Re: Docket No. E-100, Sub 165  
2020 Biennial Integrated Resource Plans and Related 2020 REPS Compliance  
Plans  
**Initial Comments of the North Carolina Sustainable Energy Association and  
the Carolinas Clean Energy Business Association on Duke Energy Carolinas,  
LLC and Duke Energy Progress, LLC's Integrated Resource Plans**

**INITIAL COMMENTS OF THE NORTH CAROLINA SUSTAINABLE ENERGY  
ASSOCIATION AND THE CAROLINAS CLEAN ENERGY BUSINESS  
ASSOCIATION ON DUKE ENERGY CAROLINAS, LLC AND DUKE ENERGY  
PROGRESS, LLC’S INTEGRATED RESOURCE PLANS**

Figure 2: DEC and DEP RA Study Figure 4

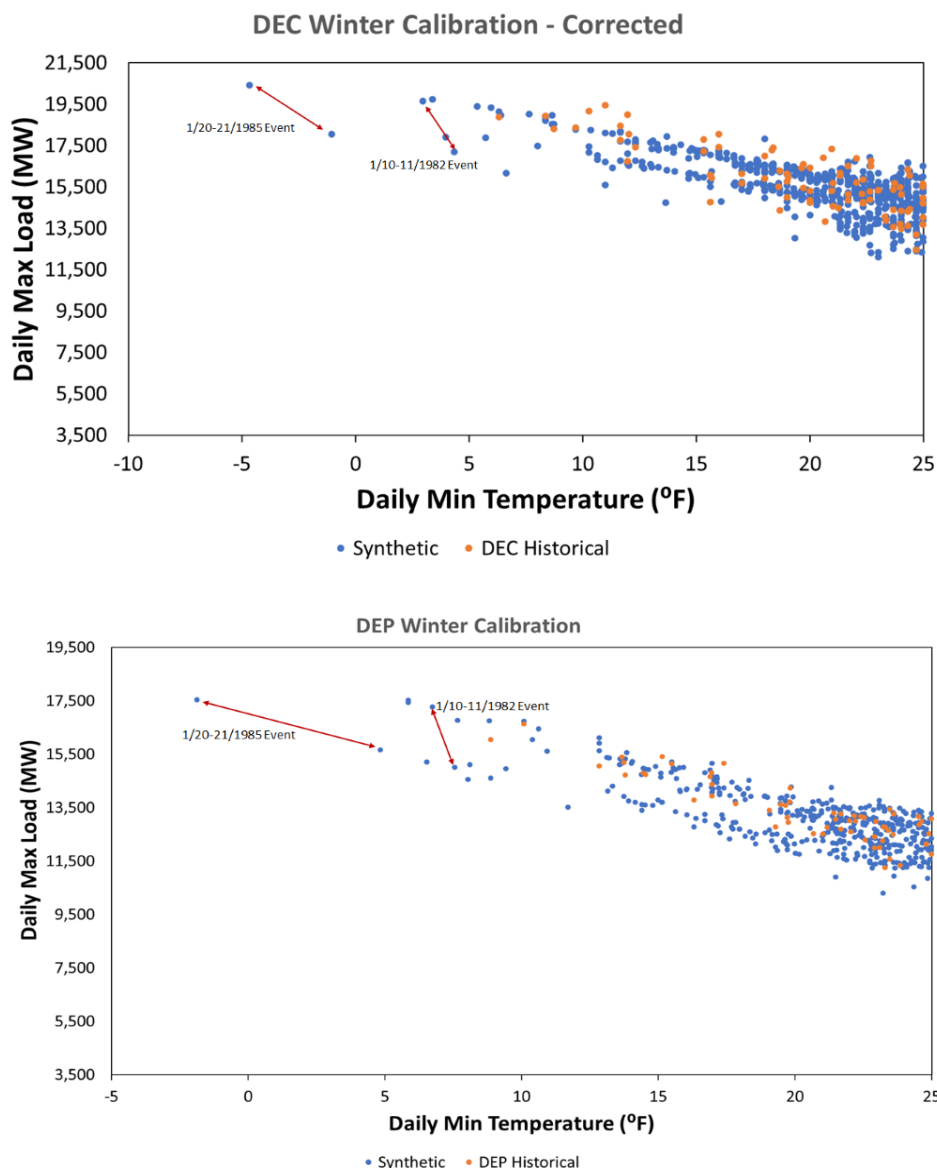
Care must be taken when interpreting Figure 4 from the RA Study (Figure in this report). Figure 3 shows the actual hourly temperatures and synthesized loads for DEC and DEP for the two days. Temperatures were relatively high on the morning of 1/20/1985: 38 degrees for DEC and 44 degrees for DEP at 6am. Even Duke's synthesized load was reasonably low. Temperatures dropped throughout the day and minimums for 1/20/1985 were set at 11pm. Temperatures continued to drop until 7am on 11/21/1985.

Clearly, 1/20/1985 was not an extreme cold weather load day with an extreme morning load. It gets included only because temperatures started dropping before midnight heading into 1/21/1985. Figure 4 shows that DEC's third and sixth and DEP's sixth and tenth coldest days were also single events rather than two events each. There are additional extreme cold weather days in the analysis that are linked.

Figure 8: Artificial neural network load modeling accuracy drops significantly at lower temperatures.

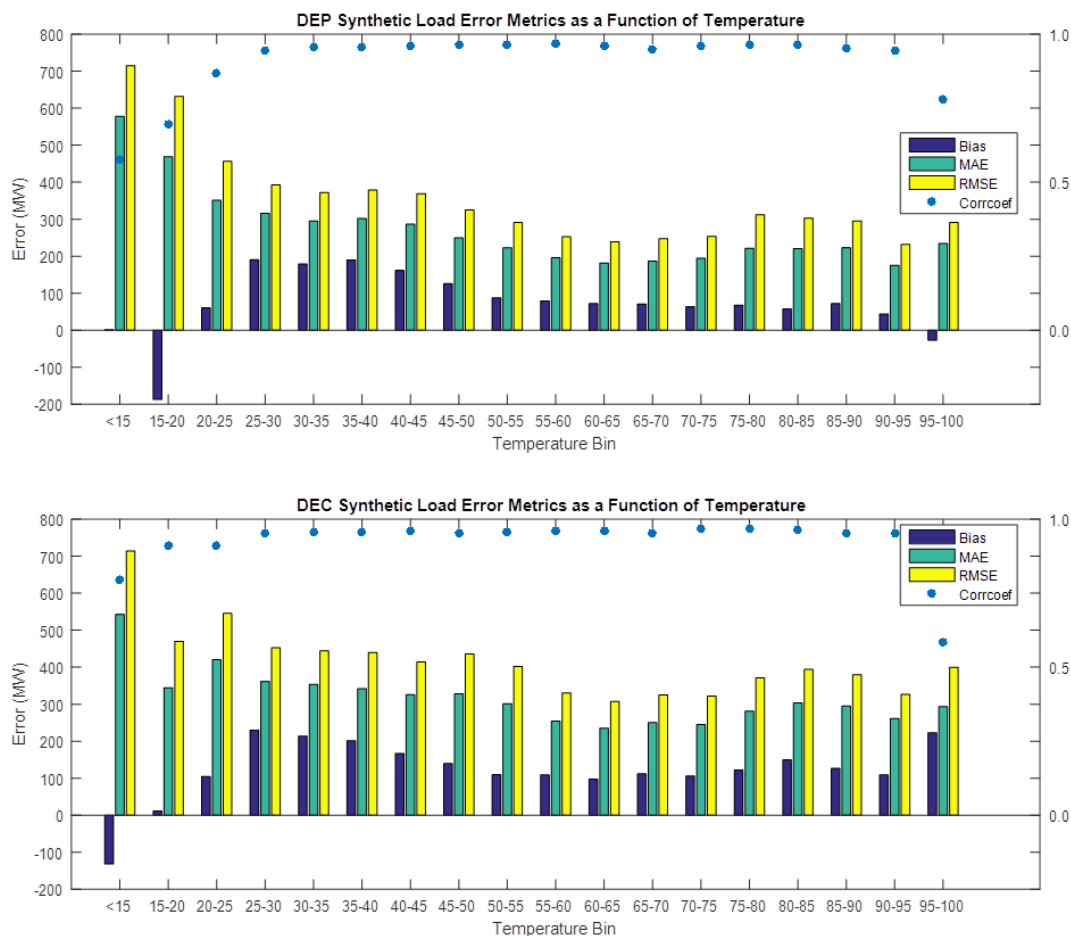
Dr. Sharp compared the synthesized loads with the actual loads to assess the accuracy of the artificial neural network load model (ANN) used to generate the hourly synthetic loads used in the IRP/RA analysis. Note that the ANN was trained with this data, so the synthesized loads would be expected to be very close to the actuals. (The appropriate way to verify an ANN is discussed below.) Figure 8 compares the synthesized load values from the ANN with the actual historic load values based on temperature. Note that the mean absolute error and the root mean square error rise dramatically, and the correlation between the synthesized and actual loads drop significantly at the lower temperatures for both DEP and DEC.<sup>30</sup> It seems probable that errors in synthesized load data will be even larger as results are extrapolated to the extreme low temperatures modeled for the 1980s, but with no actual load data that is impossible to verify.

*Figure 9: Integrated Resource Plan, Attachment V, Duke Energy EE and DSM Market Potential Study, Figure 3-16*

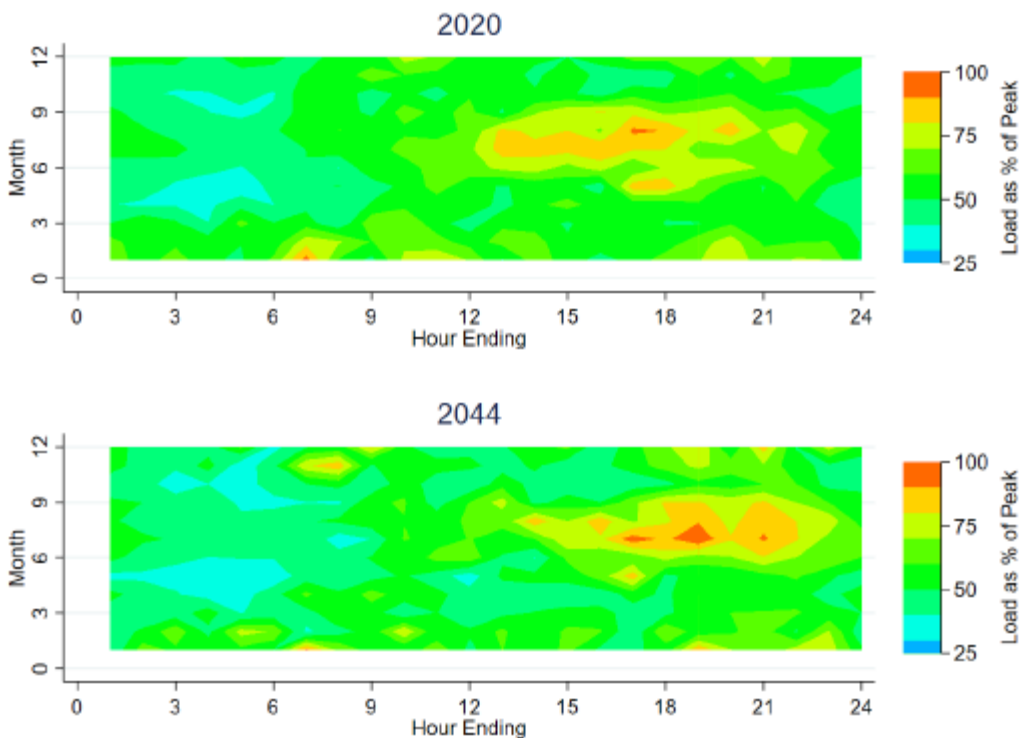
The extreme winter morning loads that Duke says drive the capacity need and low solar capacity value are hardly discernable in Duke’s Figure 3-16 (Figure 9 of these comments).

Figure 11: The IRP views EVs as a winter peak problem rather than a resource.

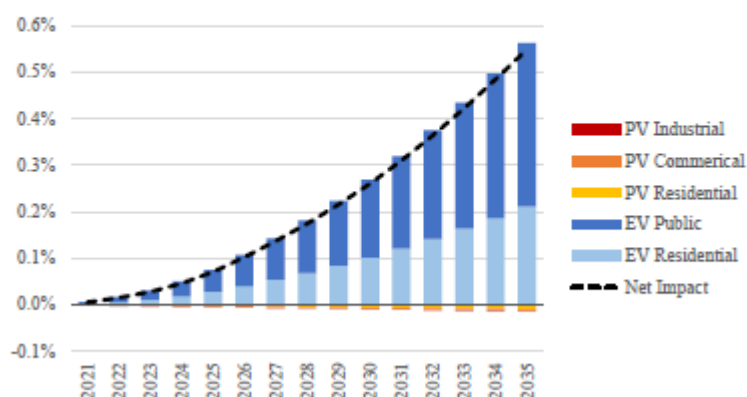
The IRP views EVs as contributing to winter morning peaks, rather than considering the possibility of utilizing them for winter morning supply (Figure 11).<sup>47</sup>

It is also not clear why residential EV charging should be adding so significantly to the early morning winter peak load (Figure 11). One would think that residential EVs would be done charging by 6am and ready for the morning commute. If residential EV charging is just starting in the early morning it could be delayed to reduce the extreme winter peak, similar to commercial EV charging.

Figure 13: RA Study Figure 1 shows the modeled limited interconnection topology.

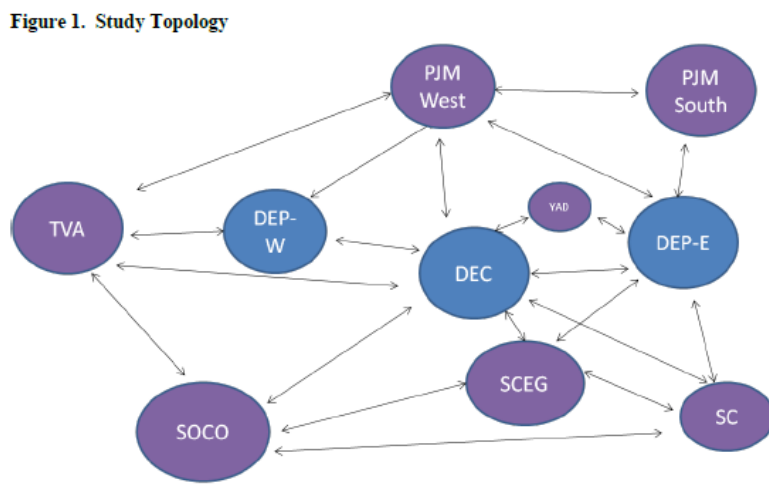
better, but even this is irrelevant, again because DEC and DEP are part of the Eastern Interconnection and should always be modeled as such. When Duke did model DEC and DEP as interconnected, they only modeled neighbors that are one tie away (Figure 13).<sup>49</sup> This is overly conservative and ignores the reliability and economic benefits Duke continuously inherently receives through interconnected operations.

Figure 15: Economic Reserve Requirements for DEC (left) and DEP (right)

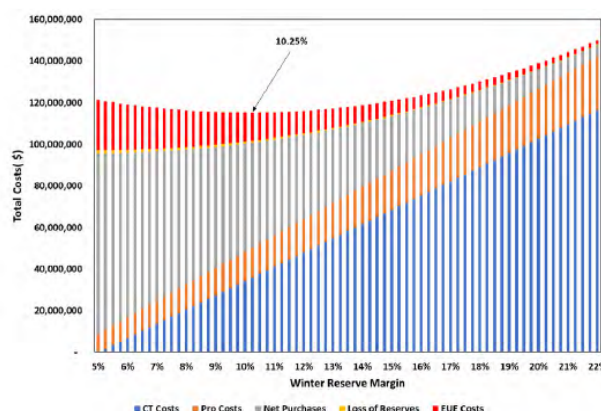
Figure 15 shows that DEC reserves of 15% and DEP reserves of 10.25% result in the lowest cost for customers based on analysis of all weather years, load forecast uncertainty, and unit performance. Unfortunately, Astrape did not perform a similar analysis for DEC and DEP combined. Nor did they perform the analysis with reasonable assumptions for interconnection support.

Figure 4: Visual Representation of the Duke IRP Process<sup>4</sup>

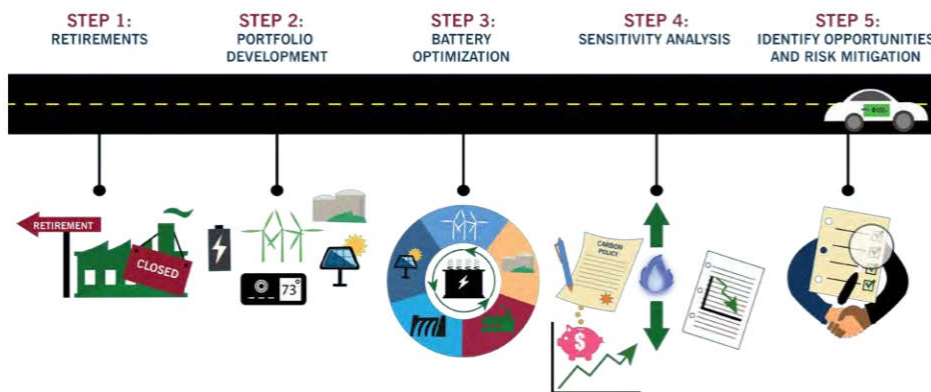
In conducting its 2020 IRP, Duke sequentially analyzed coal retirements, portfolio development, and battery optimization. In other words, Duke used multi-step optimization rather than single step optimization in its IRP. An illustration of this process from Duke's IRP is provided in Figure 4.

Figure 14 - Duke Annual Natural Gas Forecast - IRP Figure A-2

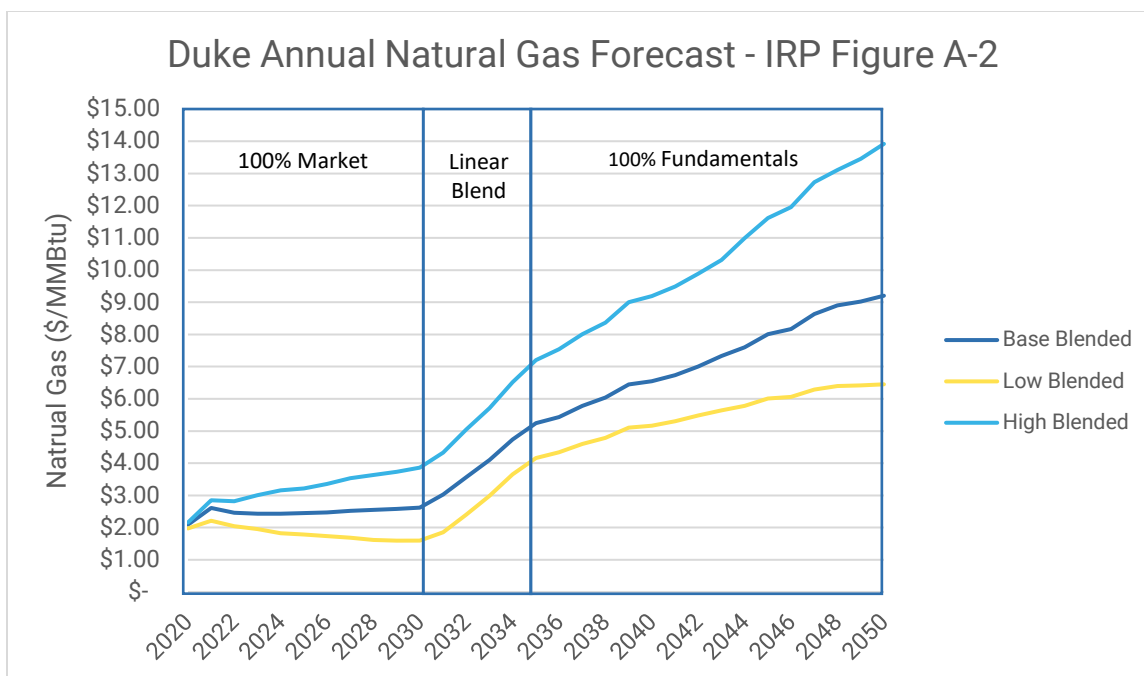
Duke based its forecast on "market prices" from financial instruments that were prices based on natural gas futures contracts for years 1 through 10, transitioned linearly to a fundamentals-based forecast from years 11 to 15, before utilizing a fundamentals-based forecast from year 16 forward. The Company also developed a high- and low-price sensitivity, applying a statistical methodology to market prices before transitioning to two EIA AEO fundamentals-based forecast scenarios.<sup>80</sup> The resulting annualized forecast is shown below in Figure 14. This is a recreation of Figure A-2 from the DEC IRP Report and clearly delineates the three disjointed sections of 100% market prices and 100% fundamentals-based forecast, joined by the five-year transition between the two.

Figure 32 - Duke Annual Low Natural Gas Forecast - IRP Figure A-2

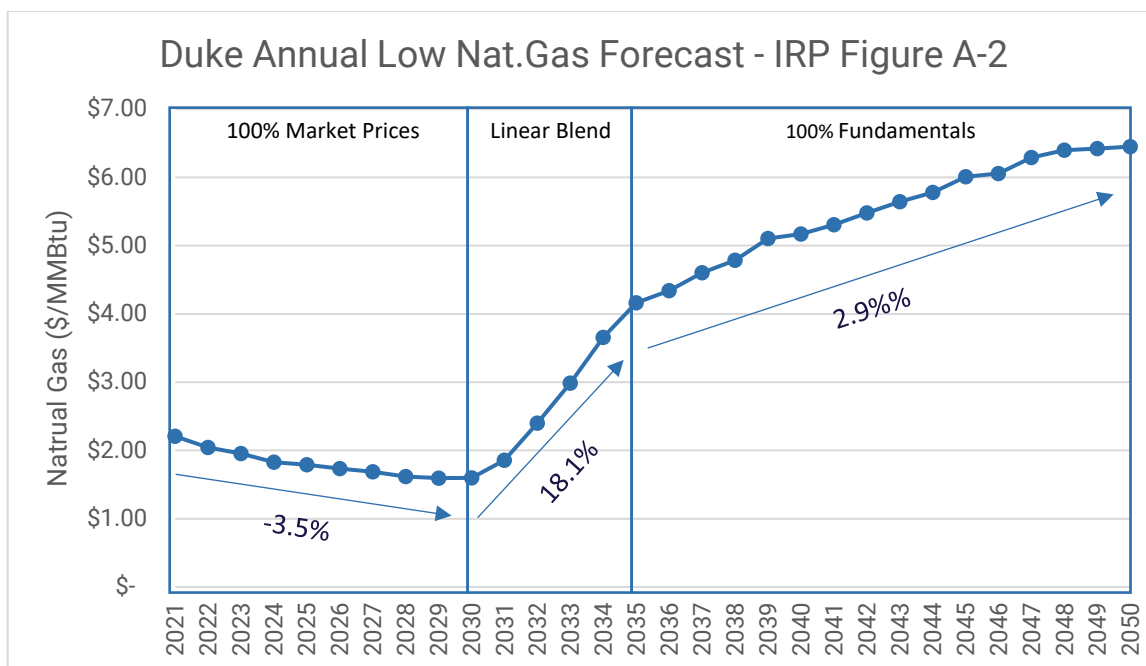
The arbitrary nature of the resulting forecast is evident in the low gas price scenario. Figure 32 below, a reproduction of the DEC IRP Report Figure A-2, shows the implausible result that Duke's approach produces. Duke expects the natural gas industry to reduce prices after inflation by 3.5% per year in the 2020s, then increase at an annual rate of more than 18% between 2030 and 2035, before slowing growth to an annual rate of 2.9% from 2036 and beyond. It is difficult to fathom a combination of policy scenarios that would produce this curve exactly because no combination of policy scenarios would produce this curve.

*Figure 37 - Resource Adequacy Study Topology*

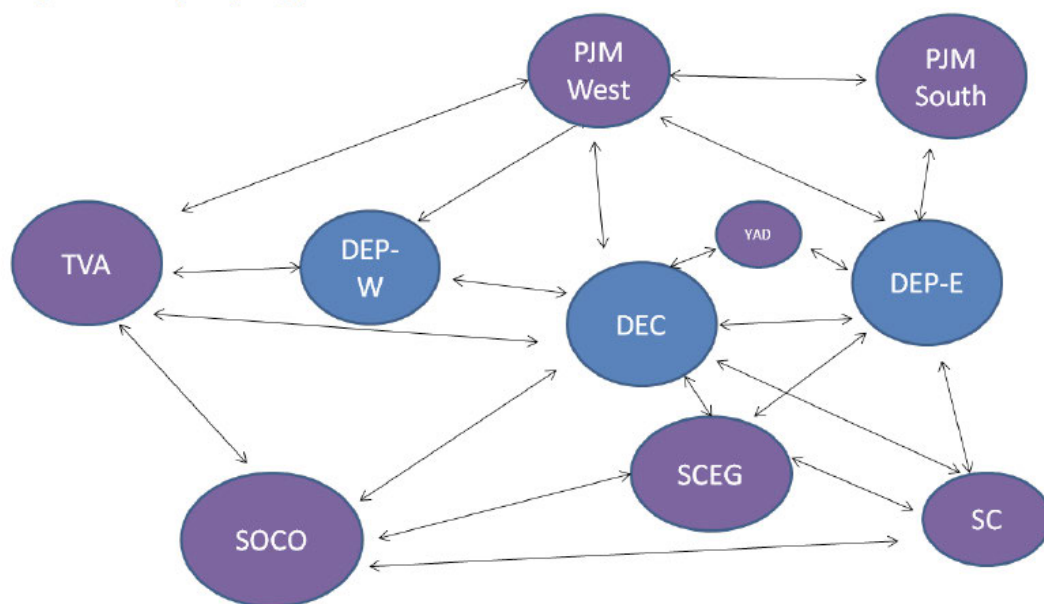
Astrapé Consulting identified the basic topology of Duke’s power grid as modeled in its resource adequacy study. In its DEP and DEC 2020 Resource Adequacy study (“RA Study”), Astrapé properly assumed that Duke’s companies were interconnected to several neighboring systems. Figure 37 below is taken from the RA Study and shows the east and west region of DEP and DEC along with other systems such as TVA, PJM, and Southern Company.

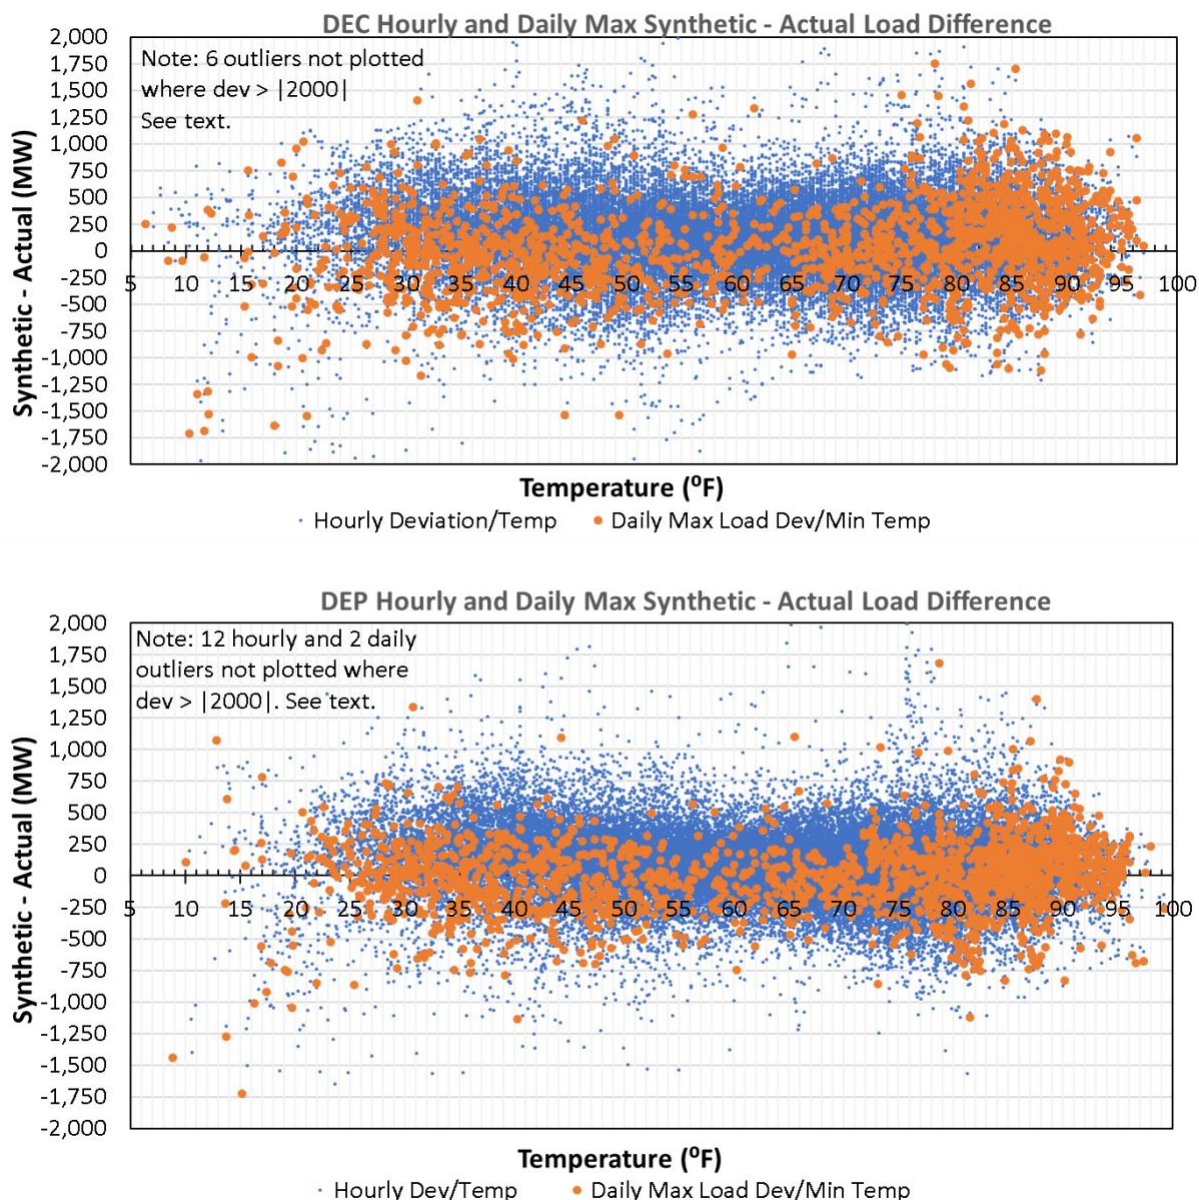
Figure 4 of the DEC and DEP RAS document did not provide an adequate validation of the quality of the model since the large number of synthesized days plotted made it impossible to see how well days with both actual and synthetic data matched. Given our concerns about the methodology, we compared the synthetic and actual loads by plotting the delta resulting by subtracting the historical from the synthetic load (so positive values are where the synthetic load is too high, negative where it is too low). The results are shown in Figure 1, where one can see that some of the errors are large, even during periods of relatively moderate temperatures where loads are typically low. Some values had to be excluded in order to reasonably scale the y-axis. See caption for details.
